Attachment C

PG&E's Comments on the North Fork Feather River Listing for Mercury

WATER SEGMENT: North Fork Feather River (NFFR) below Lake Almanor (The proposed 2008 listing included the entire 56+ mile stretch from below Lake Almanor to Lake Oroville – without any segmentation)

Figure C-1. Water Segment Delineation and Actual Sampling Locations in the NFFR Project (Belden Forebay) and Poe Project (Poe Reservoir and downstream of Poe Powerhouse in Big Bend Reservoir).

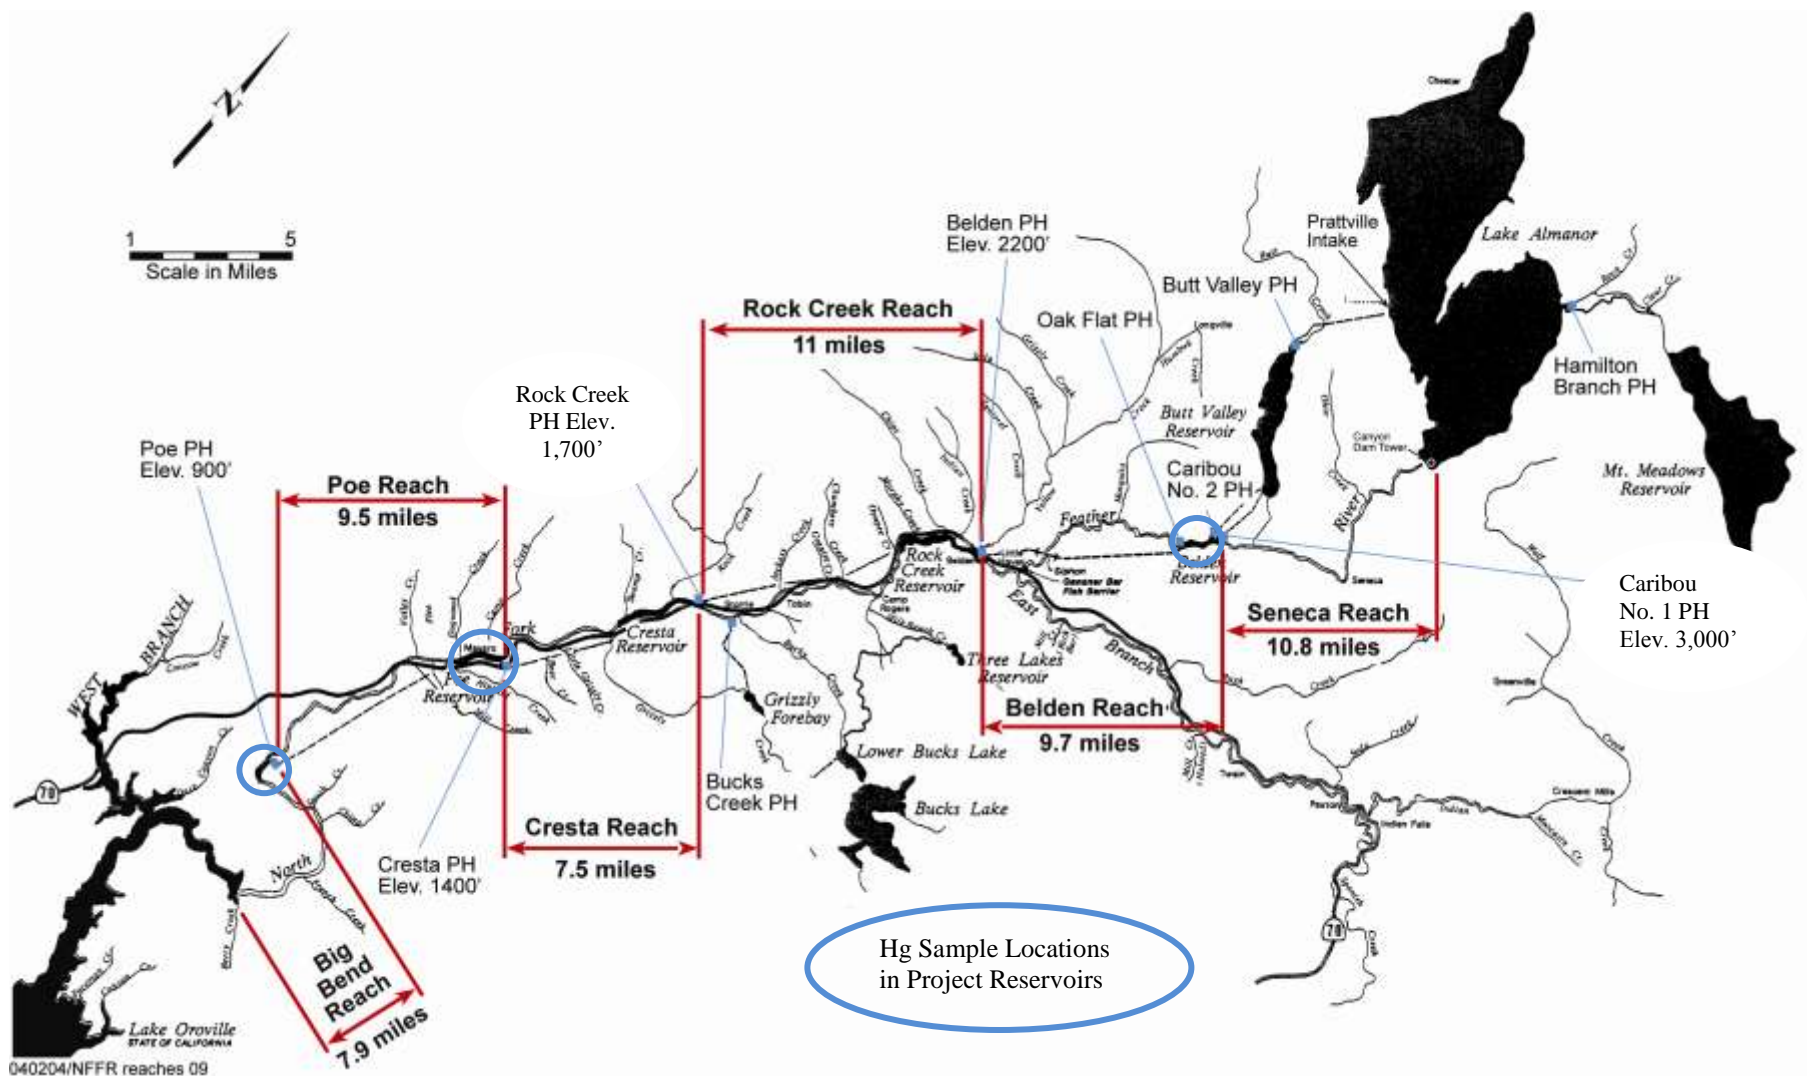
PG&E has provided factsheets for each reach of the NFFR (Seneca, Belden, Rock Creek, Cresta, Poe, and Big Bend) in this submission (see Figure C-1). Factsheets for the Seneca, Belden, Rock Creek, Cresta, and Poe reaches demonstrate that these reaches should not be listed for mercury because known available data do not indicate impairment or there are no known data available to make a determination regarding listing. The only water segment with known available data that does show possible impairment for mercury in fish tissue is the Big Bend Reach (in Big Bend Reservoir only).

**PG&E
RECOMMENDATION:** Address potential for listing by water segments (river reach) and delist or list based upon known available data or evidence for each individual water segment. Based upon known available data the CVRWQCB should list only the Big Bend Reach (in Big Bend Reservoir specifically) for mercury. CVRWQCB should not list Seneca, Belden, Rock Creek, Cresta, and Poe reaches of the NFFR for mercury based upon the known available data.
